Affirm[®]

Prone Biopsy System

1.1 Customer Release Notes

MAN-06082 Revision 001

3.3.2 Additional Indicator to Accept/Reject Targets

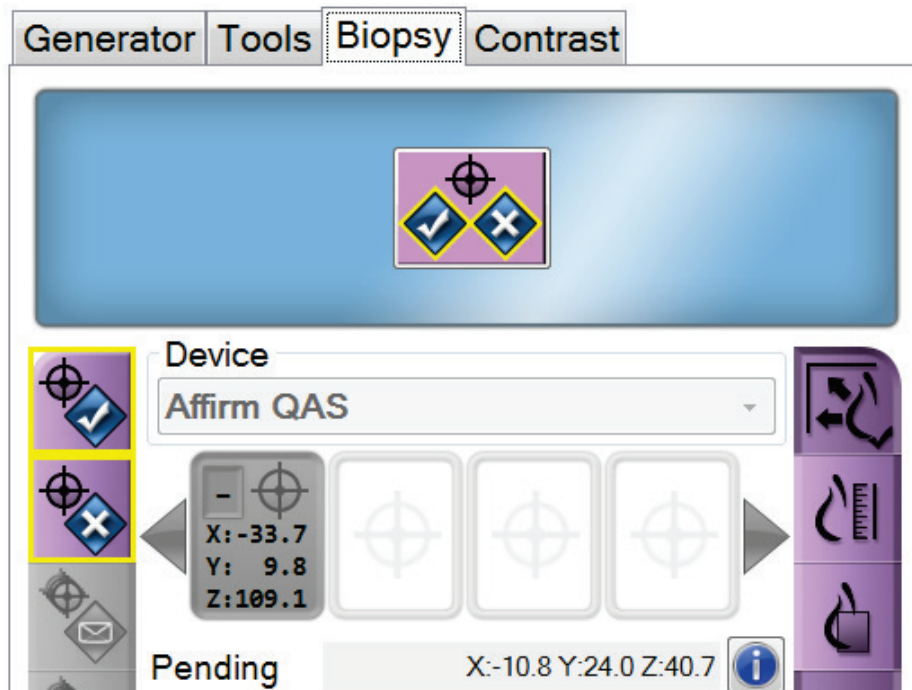
After a biopsy target has been created on the Image Display monitor, the System Messages panel now displays the indicator with a blue background (see the following figure) to alert the operator to Accept or Reject the target.
